# Consideration of max\_wait\_timer

Comment # 315

Xuebo Wang, Guangcan Mi  
Huawei

Figure 178B-10—Training control state diagram

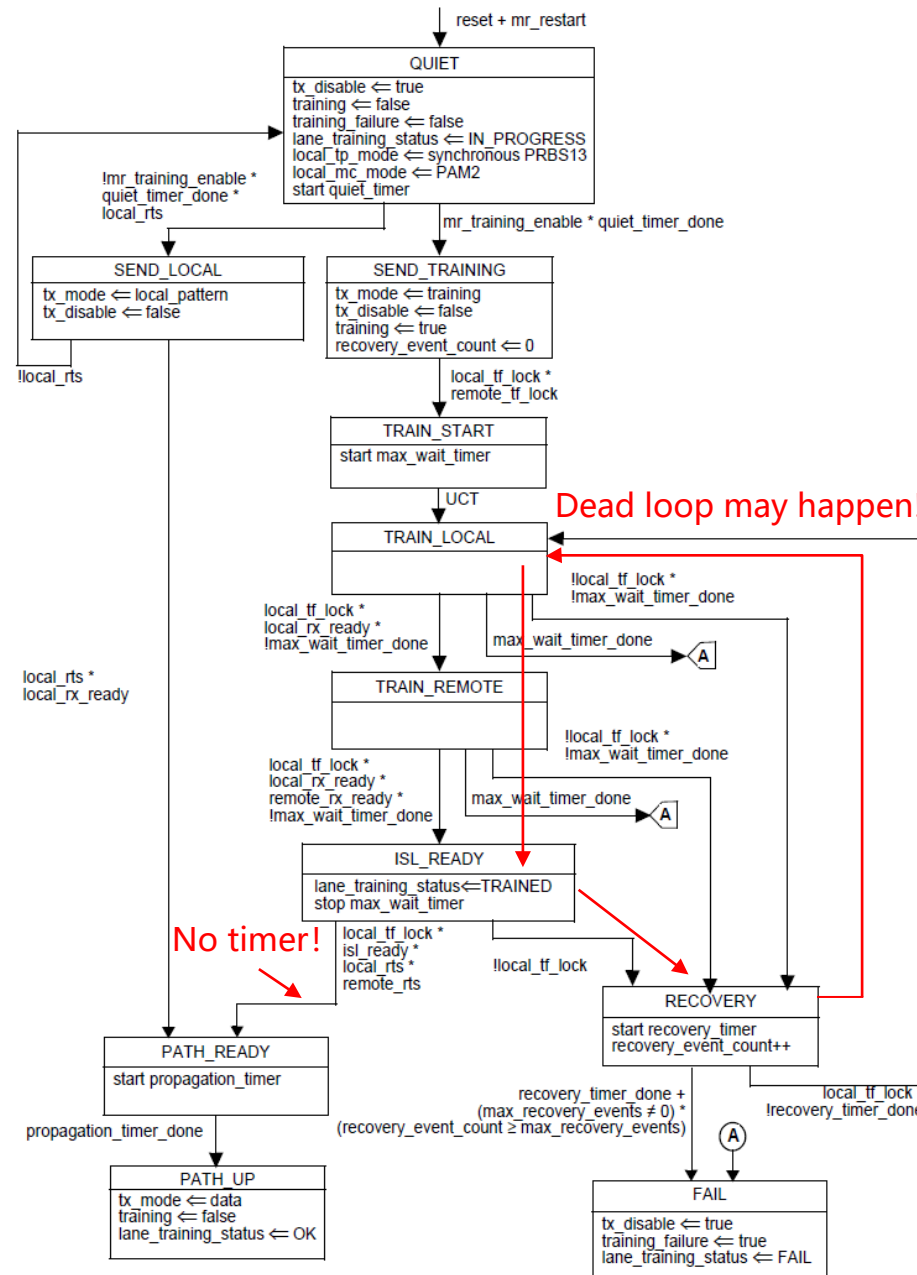
- No worries before ISL\_READY. Time spent from TRAIN\_LOCAL to ISL\_READY with potential recovery is included.
  - Once entering ISL\_READY, **no timer used to bound ISL\_READY→PATH\_READY**. If local\_rts or remote\_rts keeps false due to disconnected interfaces or broken ISLs elsewhere over the path,
    - **Path start up cannot be achieved before debugging.**
    - **A dead loop may exist** when training frame lock is often lost and its recovery time never exceeds the limit of recovery\_timer with max\_recovery\_events = 0.
- (ISL\_READY→RECOVERY→TRAIN\_LOCAL→...→ ISL\_READY)**

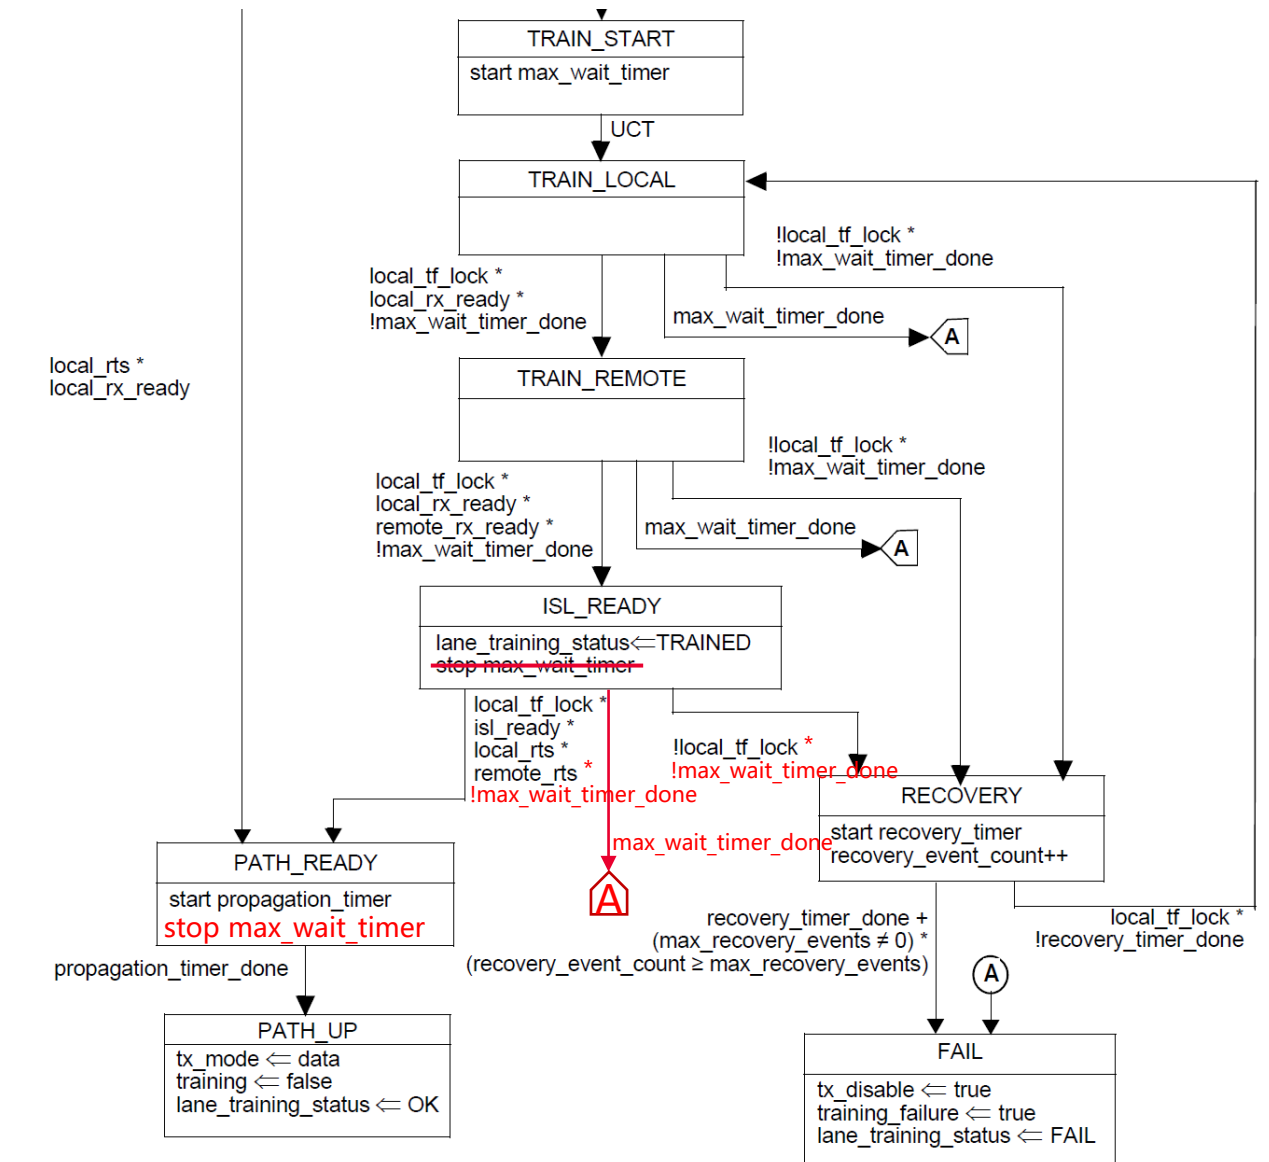
- Stop max\_wait\_timer in PATH\_READY instead of ISL\_READY.
- Add “!max\_wait\_timer\_done” condition for the transition from ISL\_READY to PATH\_READY or RECOVERY.
- Add new transition from ISL\_READY to FAIL when max\_wait\_timer\_done = true.

- Indicate users to debug if ISL\_READY → PATH\_READY has timeout to FAIL.
  - Training will restart only after debugging.
- max\_wait\_timer\_done makes effect for all possible recovery loops.
- Minimum change to FSM.
